主旨: Supplementary Information for Planning Application No. A/YL-LFS/572

### SI for A/YL-LFS/572

### Additional comments on submission for planning application no. A/YL-LFS/572

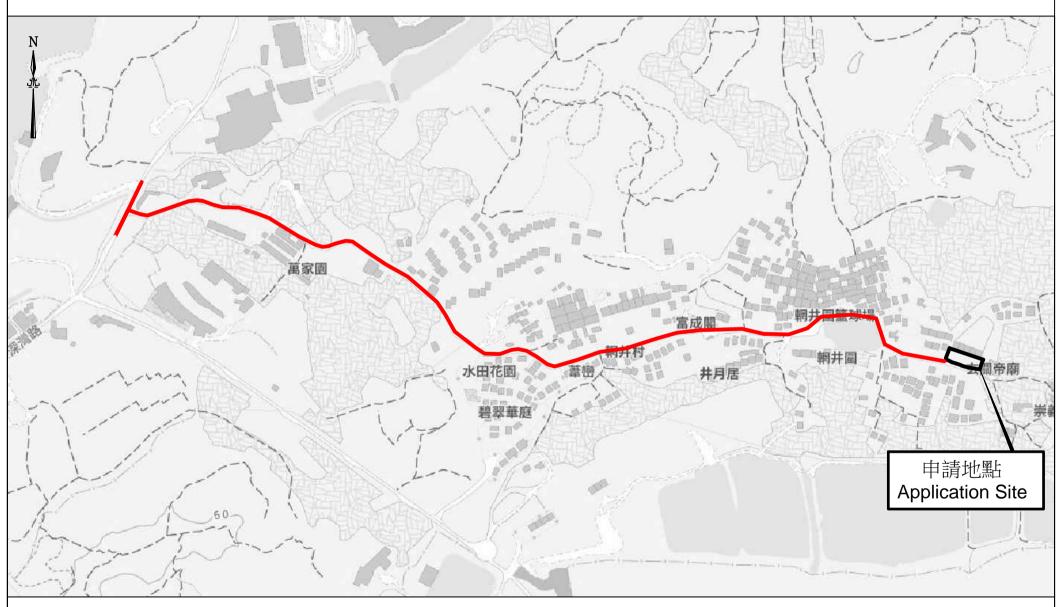
Regarding the applied filling of land, please supplement a land filling plan indicating the area, depth and material of filling of land (for your information, the applicant has indicated that the filling material was cement with reinforcement 石屎及鐵網 in the previous application A/YL-LFS/367). Also, please provide the purpose of filling of land (e.g. for maneuvering and parking of vehicles).

The area of filled soil in the aforementioned rural development land is approximately 750 square meters (including 170 square meters of government land), covering the entire application site. The filling materials include iron mesh and concrete with a thickness of 150 millimeters.

Each of the 15 parking spaces currently applied for has an area of approximately 5 meters by 2.5 meters, and they are only available for private car parking.
